SIB 51 03 20

WATER RUNS OUT OF DRIVER'S DOOR WHEN OPENING

E-Series	Model Description
G29	Z4 Roadster

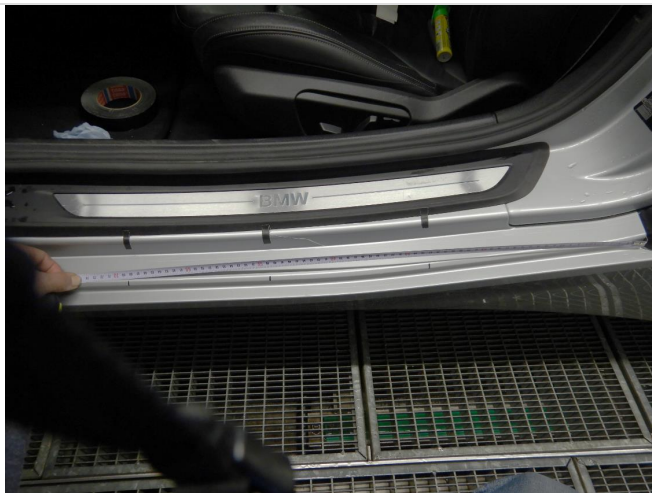
If the vehicle is parked on an incline (front higher than the rear), water may not be able to flow out of the door. Upon opening the door, water may flow out rapidly. The collected water does not run inside the car.

The door seal creates such a tight seal, that water can't flow from the door.

Rework the door seals to allow for proper drainage.

1. Starting at the rear of the door opening as shown, begin measuring towards the front of the vehicle.

Place masking tape at 270 mm, 490 mm, and 685 mm.
